RFB-2024-39
INTERIOR RENOVATIONS TO SCHENECTADY COUNTY DEPW
C2 DESIGN GROUP

ADDENDUM #3

Issued Date: 08/02/2024

| Sheet Number: | MD101 |

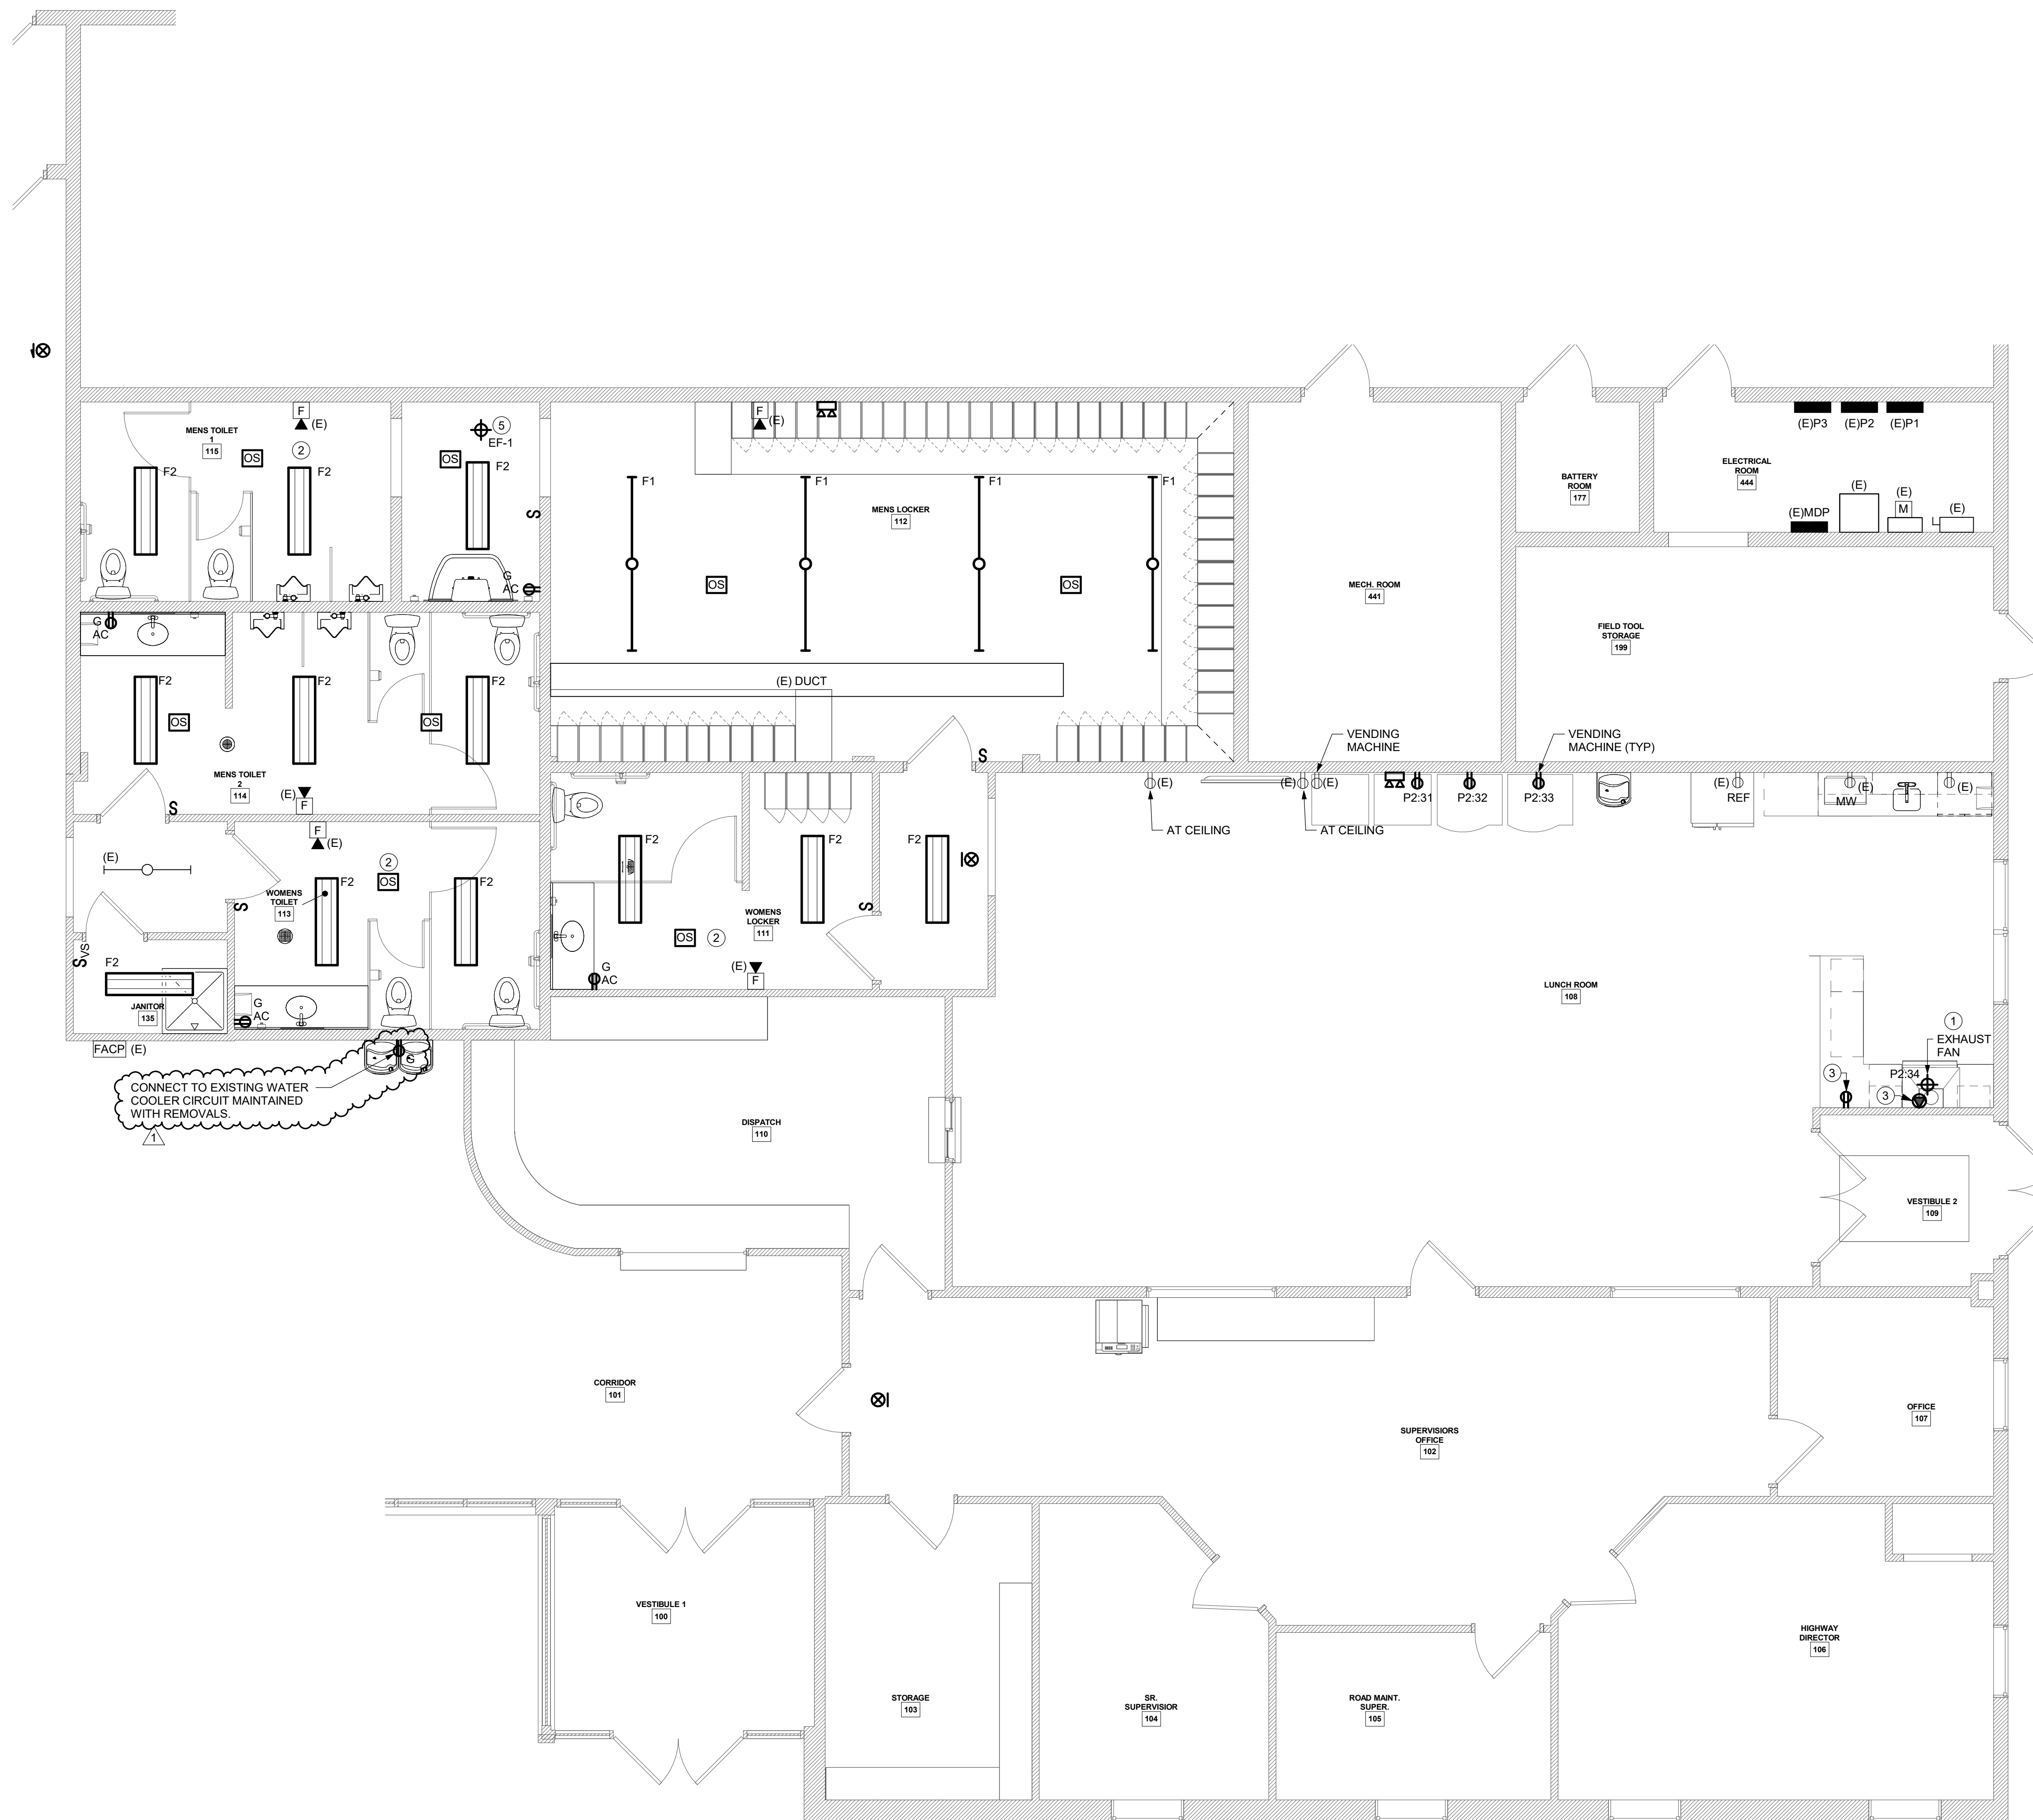
- a. Reference drawing note for Duct Cleaning
10. Drawing MD101 – First Floor Demolition Plan (Overall) - HVAC
 - a. Reference Demolition note for replacement of Supply Diffuser and Return Grilles

- DEMOLITION NOTES:**
- DISCONNECT AND REMOVE EXISTING SUPPLY AIR TERMINAL AT THIS LOCATION. PREPARE FOR FUTURE CONNECTION TO NEW.
 - DISCONNECT AND REMOVE EXISTING RETURN AIR TERMINAL AT THIS LOCATION. PREPARE FOR FUTURE CONNECTION TO NEW.
 - DISCONNECT AND REMOVE EXISTING EXHAUST FAN ON ROOFTOP. PREPARE DISCONNECT AND ROOF CURB FOR CONNECTION TO NEW.
 - DISCONNECT & REMOVE EXISTING 10" ROUND DUCT, FLEX SUPPLY AND EXISTING SUPPLY AIR DIFFUSER. PATCH EXISTING DUCTWORK AIR TIGHT.
 - DISCONNECT AND REMOVE EXISTING RETURN AIR TERMINAL AT THIS LOCATION.
 - REPLACE EXISTING SUPPLY DIFFUSER AT THIS LOCATION WITH A TYPE 1, SIZE ACCORDING TO NECK SIZE INDICATED AND BALANCE TO CFM INDICATED. TYPICAL OF ALL SUPPLY DIFFUSERS.
 - REPLACE EXISTING RETURN GRILLES AT THIS LOCATION WITH TYPE A GRILLE, SIZE ACCORDING TO NECK SIZE INDICATED AND BALANCE TO CFM INDICATED. TYPICAL OF ALL RETURN GRILLES.

1 ENLARGED FIRST FLOOR PLAN (EAST) - ELECTRICAL
E102 SCALE: 1/4" = 1'-0"

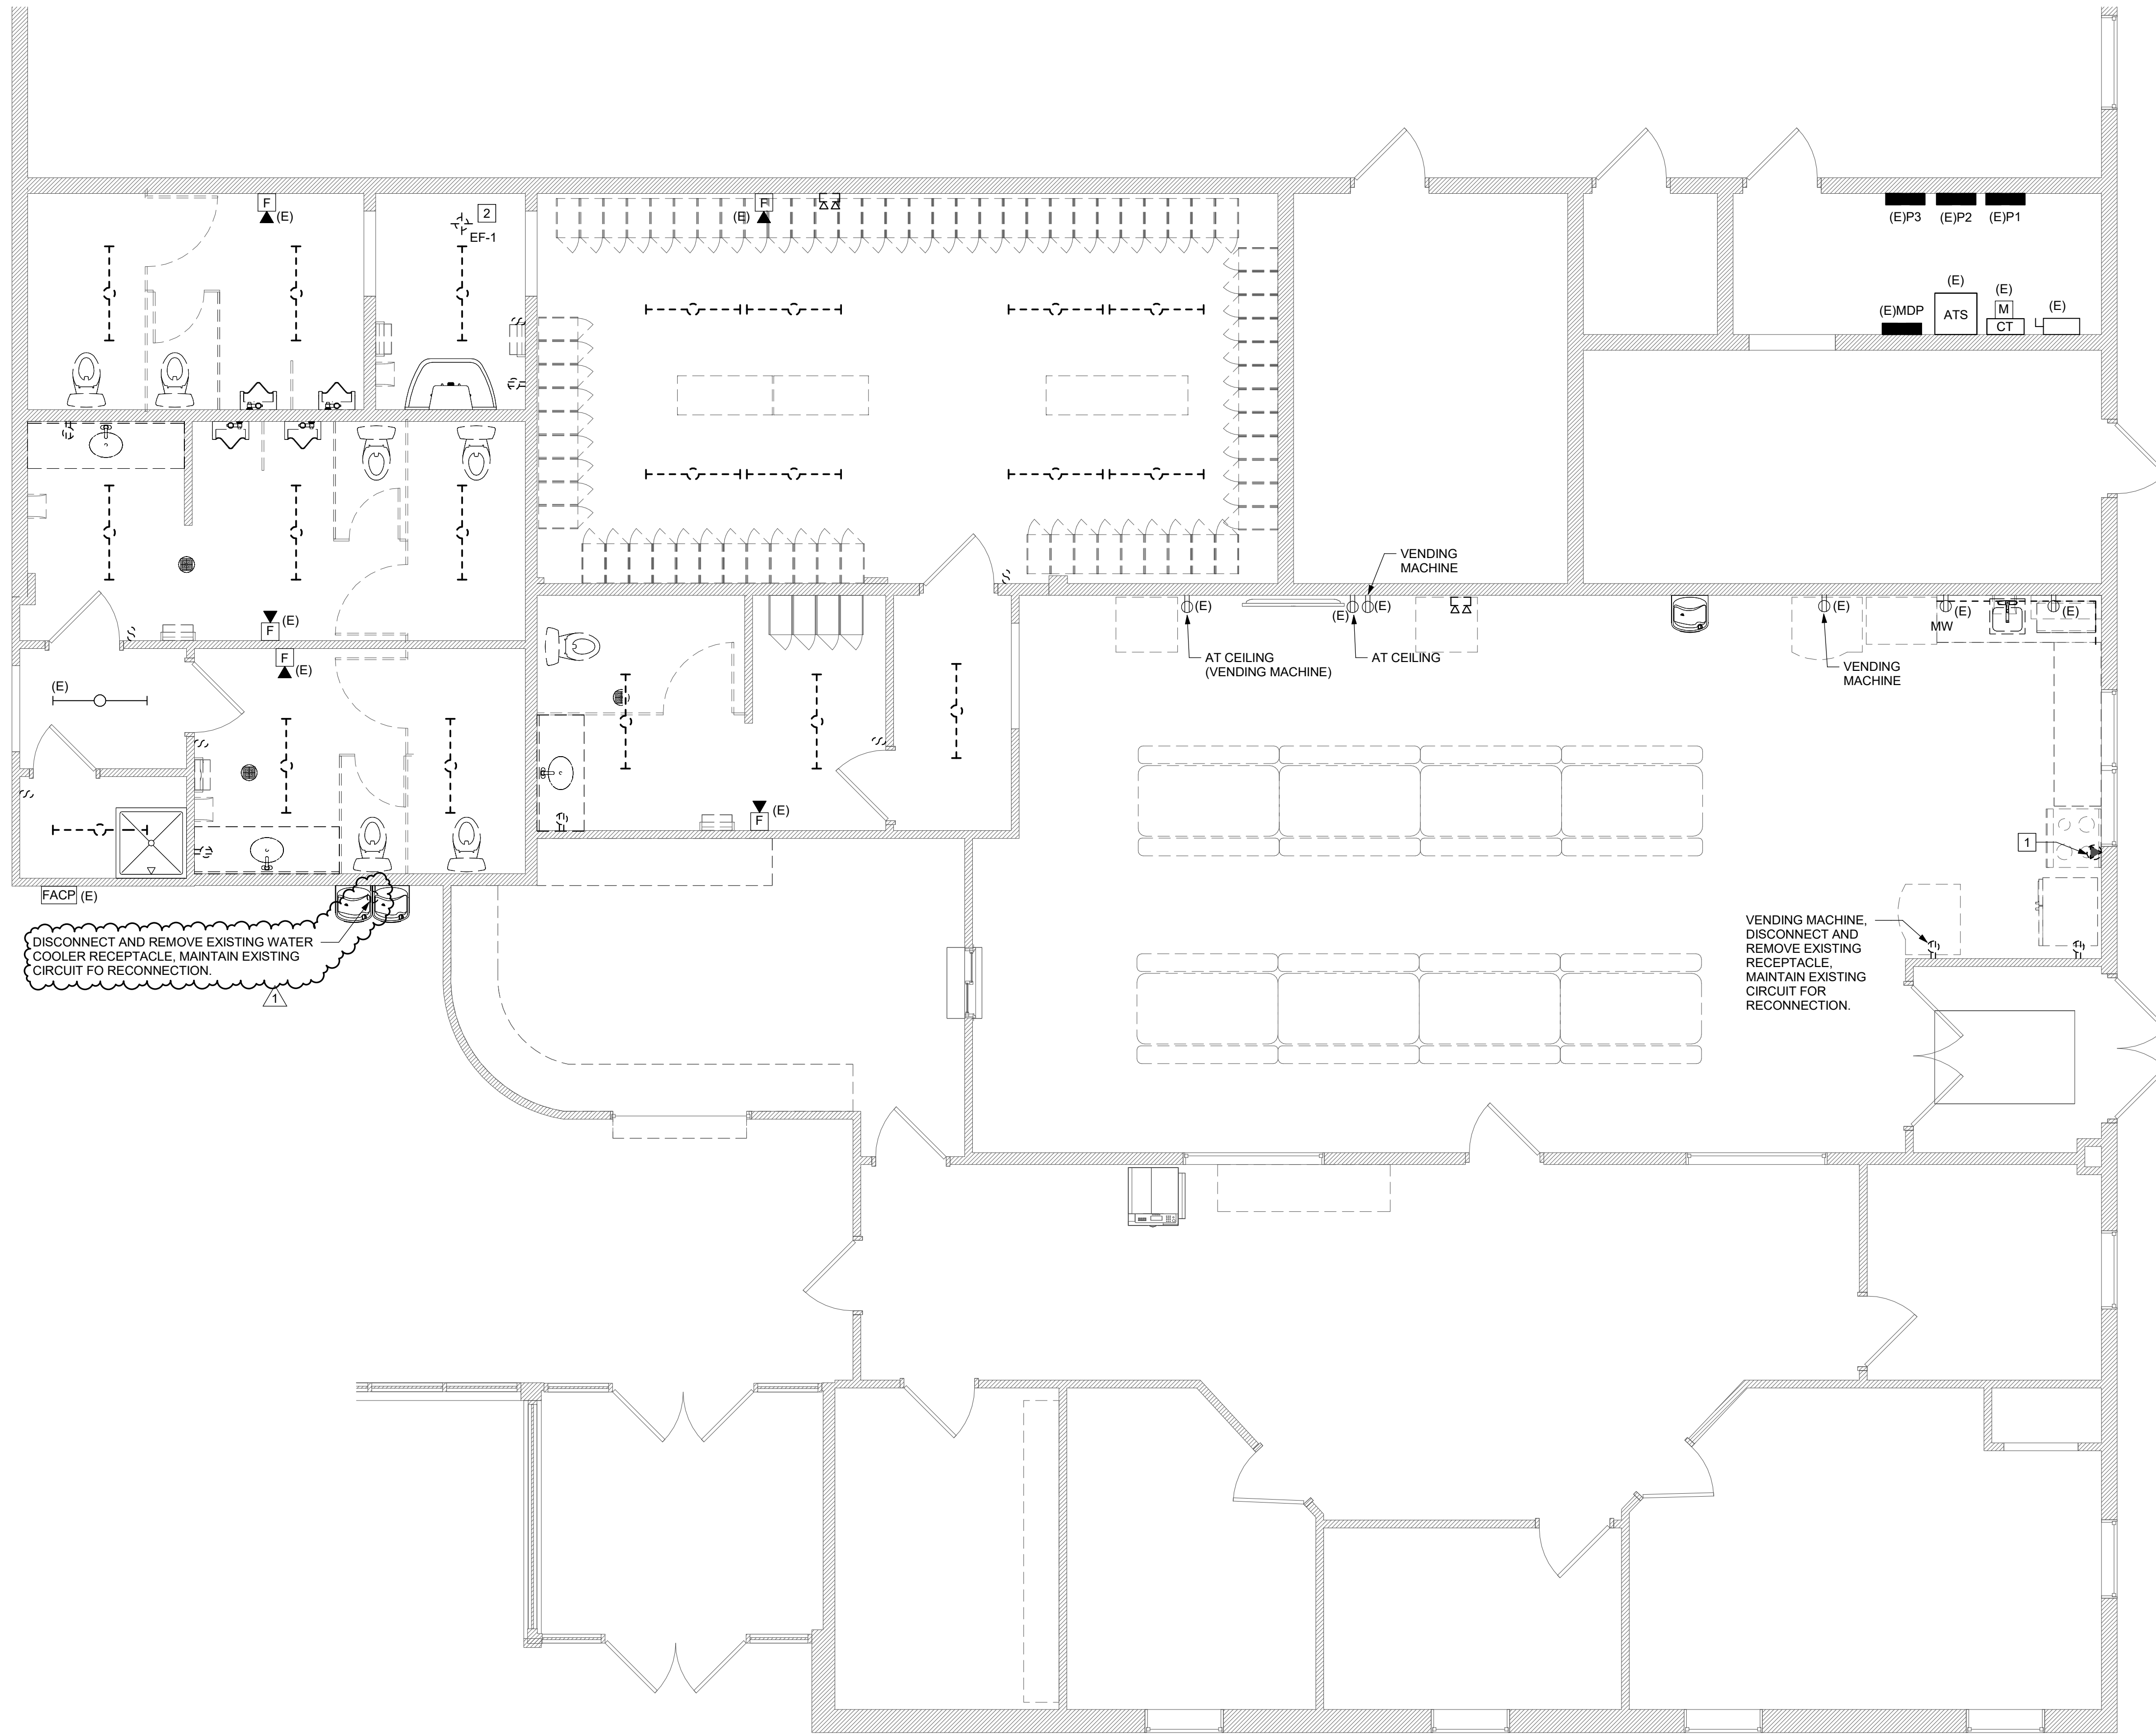
11. Drawing E102 – Enlarged First Floor Plan (East) - Electrical
 - a. Reference drawing note for Water Cooler power.
12. Drawing E102 – Enlarged First Floor Plan (East) - Electrical
